Safety Evaluation Report

related to the operation of
Limerick Generating Station,
Units 1 and 2

Docket Nos. 50-352 and 50-353

**U.S. Nuclear Regulatory
Commission**

FIG. 1 - Extreme wind speeds (mph) as estimated in the Report.

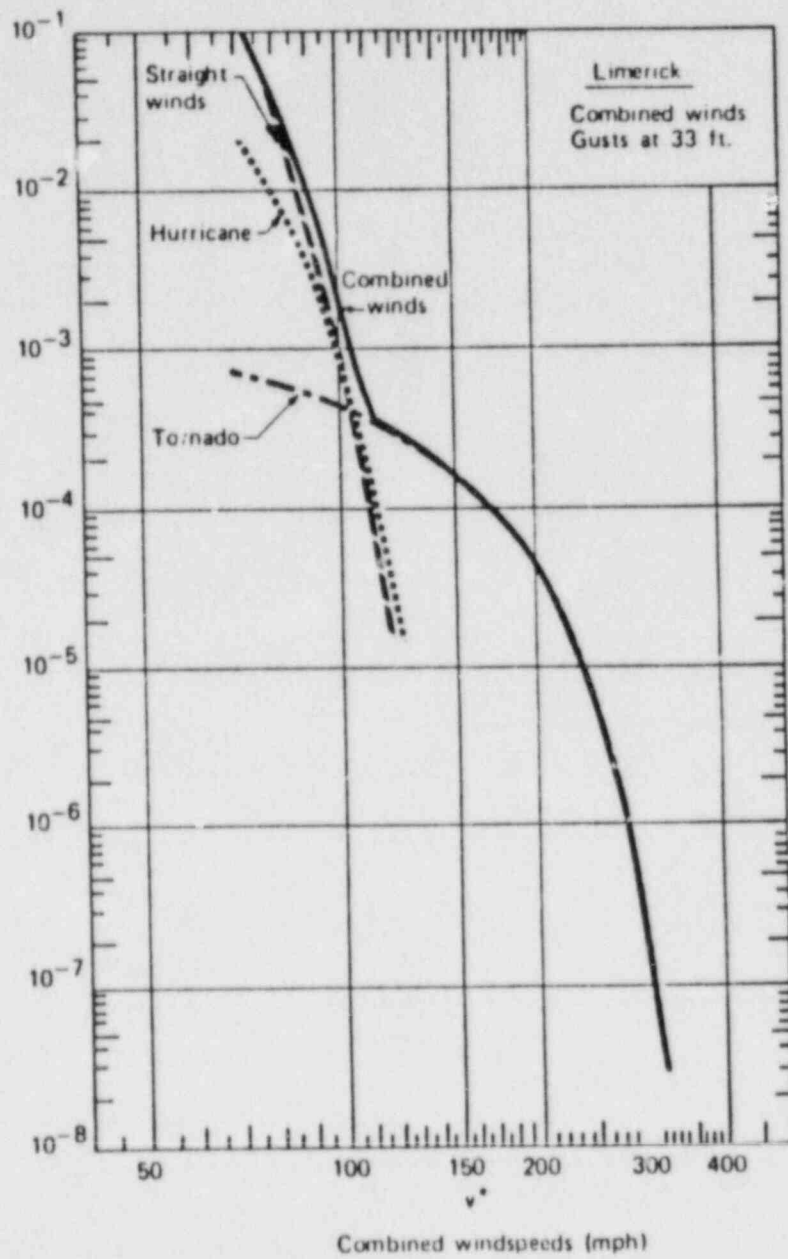
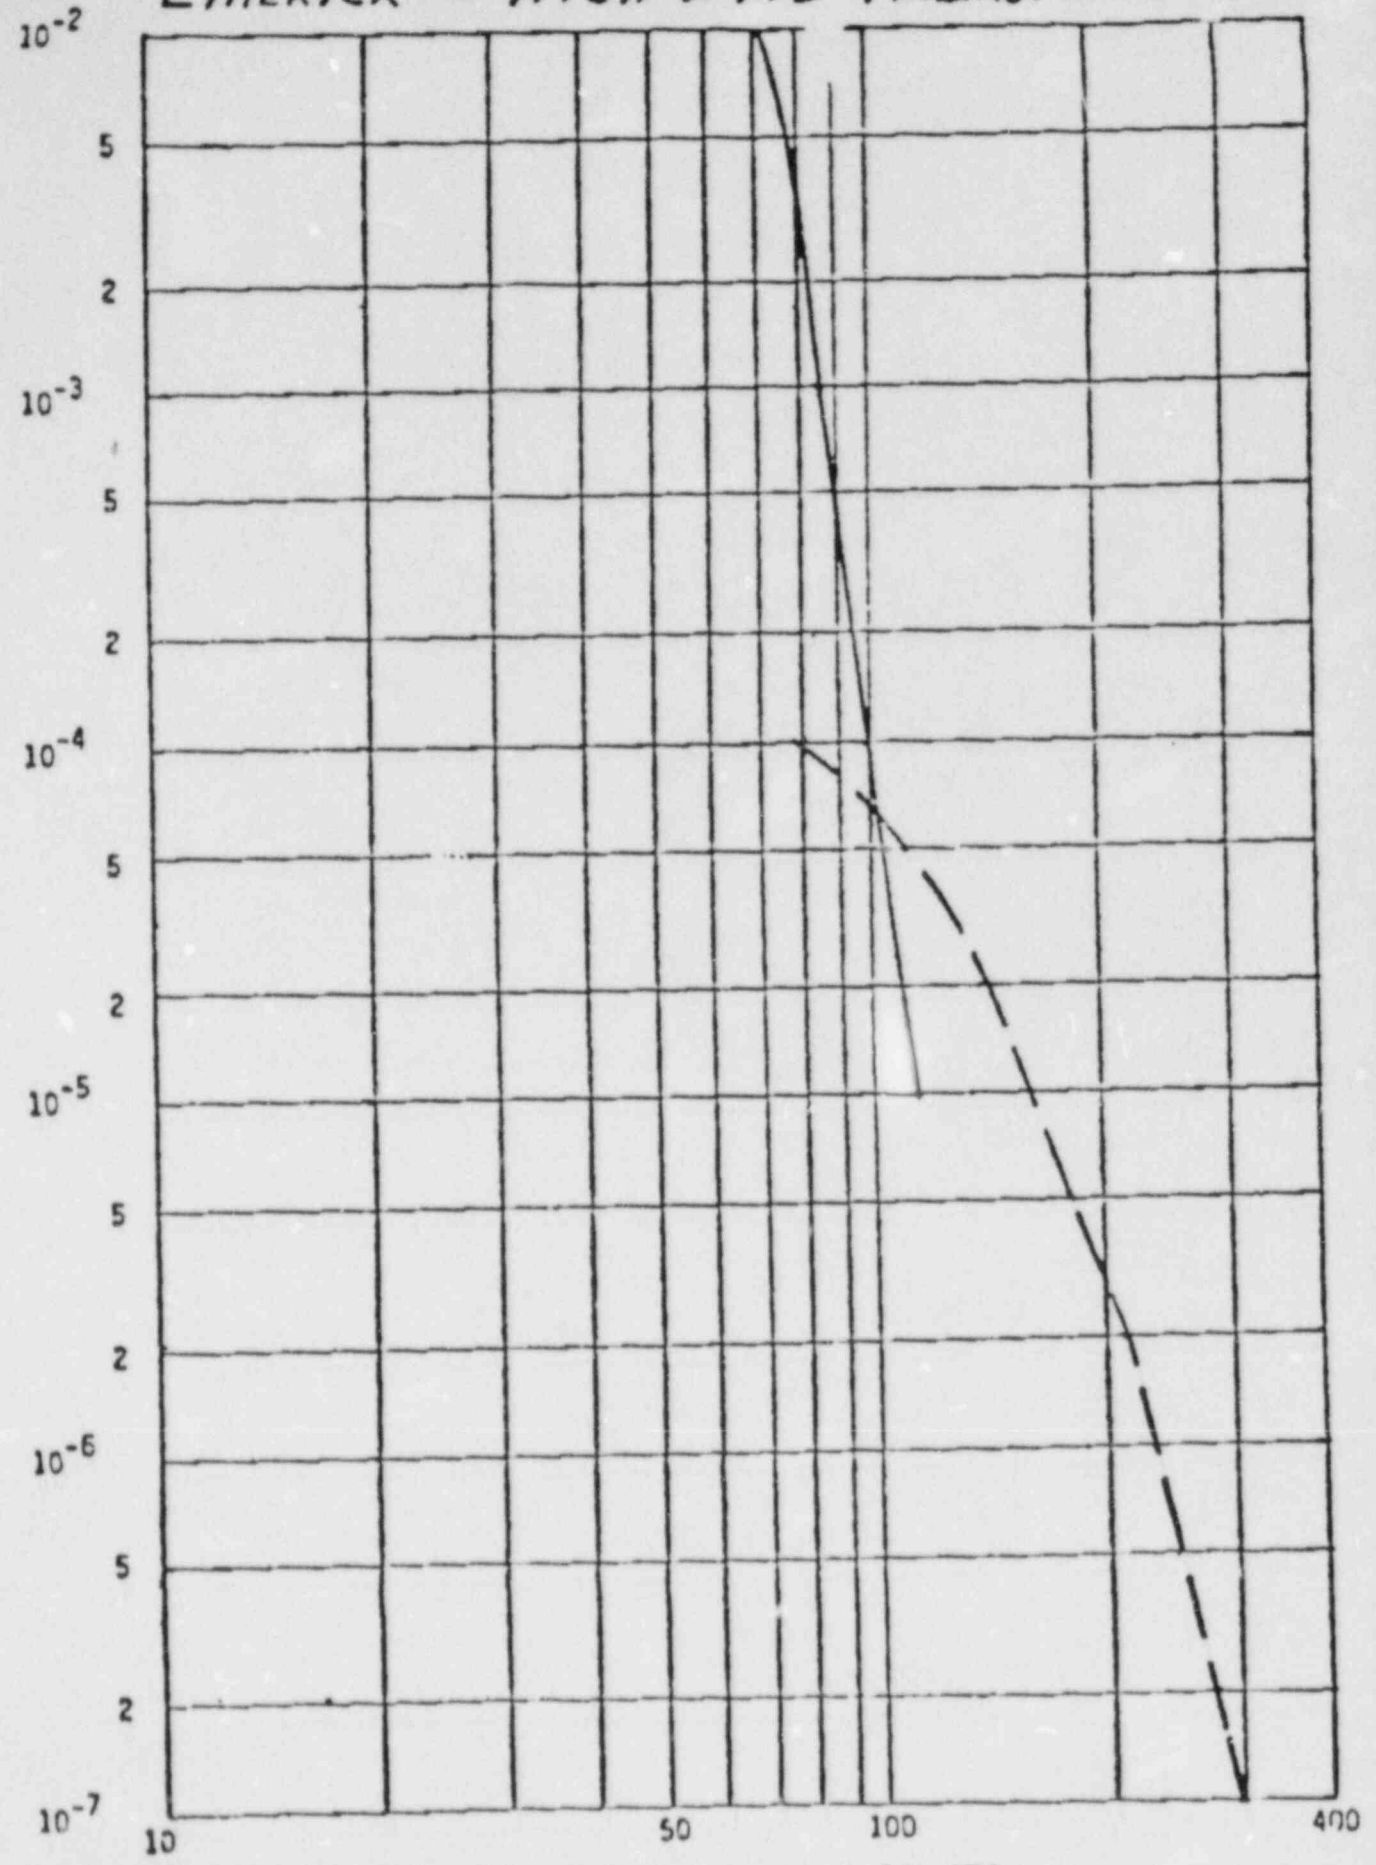
According to reference 2, these failure speeds are based on the assumption that Venturi (or interference) effects are not significant. This assumption may not be correct. This is suggested by Figs. 3 and 4, which show, for two cases, the ratios between tower stresses in the presence and in the absence of interference effects: these ratios may be as high as 15%, or even 30%. (In Figs. 3 and 4, $\min n_{22}$ = meridional compression, $\max n_{22}$ = meridional tension,

FIG. 4 - (from Reference 4)

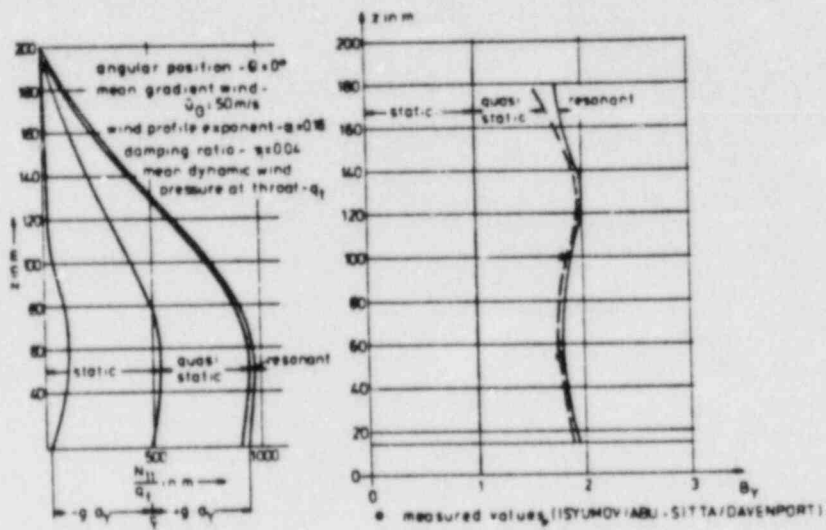
On the other hand, in estimating the failure speed of the tower, the Report assumed that the pressures induced by the 2-sec wind gusts are perfectly correlated over the entire surface of the tower (see ref. 6). To this assumption there would correspond a gust response factor for the tower (i.e., a ratio between the response induced by the 2-sec wind gust and the response due to the mean hourly wind) of the order of 4.0. In reality, owing to the fact that spatial pressure correlations are imperfect, the gust response factor is significantly less than 4.0. (See Fig. 5.)
